Mountaineer Bottom Ash Complex Report

**Lockheed Martin
Contractor for the USEPA**

October 2009

Photo Number:
10

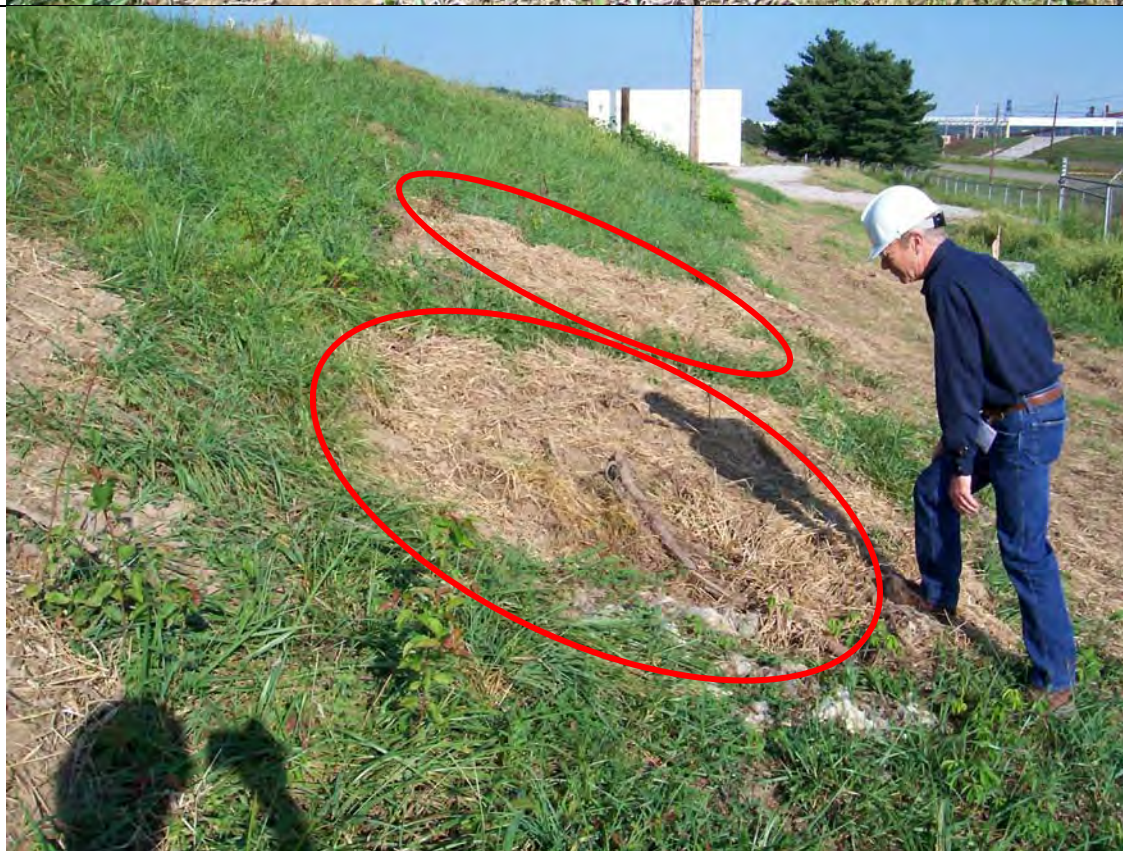
- Isolated sloughing of surface soil was observed along the east embankment where trees and shrubs were recently removed. The sloughing was observed occurring in locations where vegetative cover had not yet reestablished (Appendix B – Photo 10).

Description:
Area on east embankment where trees were recently removed. Note sloughing of surface soil observed at numerous dead areas where vegetation not re-established.

Additional efforts should be taken to re-establish vegetation on the outboard embankment slope of the east dike where trees were recently removed.
